Project Name/Address: 104 E Gilman, Kendall House
Application Type: Certificate of Appropriateness for exterior alteration on a landmark site and in a historic district
Legistar File ID # [52418](#)
Prepared By: Amy L. Scanlon, Preservation Planner, Planning Division
Date Prepared: July 16, 2018; revised July 25, 2018

Project Applicant/Contact: Dan O’Callaghan
Requested Action: The Applicant is requesting that the Landmarks Commission approve a Certificate of Appropriateness for an exterior alteration involving the construction of brick piers in the front porch at the Kendall House in Mansion Hill historic district.

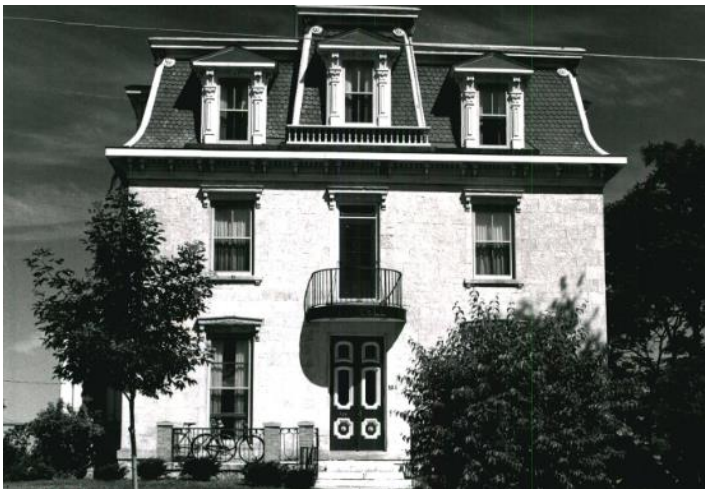
The work was constructed differently than approved. The piers were constructed in brick instead of wood and the brick was not in a color that was appropriate for the landmark building. The two middle piers flanking the front steps were constructed wider and taller than the other piers. In addition, the middle piers have been installed with conduit and wiring to receive a top mounted light fixture. Staff worked with the property owner's representative to find an agreeable solution to allow the brick piers to remain. The brick has been stained to closely match the color of the stone. In their current configuration, the piers are very similar to those shown in the photo from the 1970s except that the middle piers and the pier on the east corner are wider and taller than the other piers. There is ghost evidence on the building wall of an engaged pier on the east side of the porch.

Documentary evidence of the piers does not seem to be available so it is unknown if the original piers for the covered porch were brick or stone or wood. It may be possible that the piers shown in the photo from the 1970s are original to the construction of the covered porch. The original building did not have a mansard roof or a covered front porch as shown in the c. 1868 photo (WHI31861). The mansard roof is believed to have been added in 1873 and the porch may have been part of that same building campaign.

1. The caps of the piers that have been drilled for light fixtures shall be covered or replaced so that wiring cannot be accessed for the installation of light fixtures. It would be more appropriate to add light fixtures directed toward the stairs in a lower portion of the pier than to mount fixtures to the tops of the piers. Any light fixture installation would need the review and approval of the Landmarks Commission. If the caps are replaced, they should have a pyramidal sloped top surface instead of being flat. In addition, the overhang should be reduced so that the cap is more appropriately sized to the pier.

2. The middle piers shall be reduced in height so that they match the height of the other piers.
3. The east corner pier should be reduced in height and width so that it matches the height and width of the other piers. The cap should be made smaller so that the overhang matches the overhang of the other piers.

4. An engaged pier shall be constructed to match the existing engaged pier on the opposite side.
5. The Applicant shall provide more information about the previously installed metal railings that are proposed to be reinstalled for Commission review.
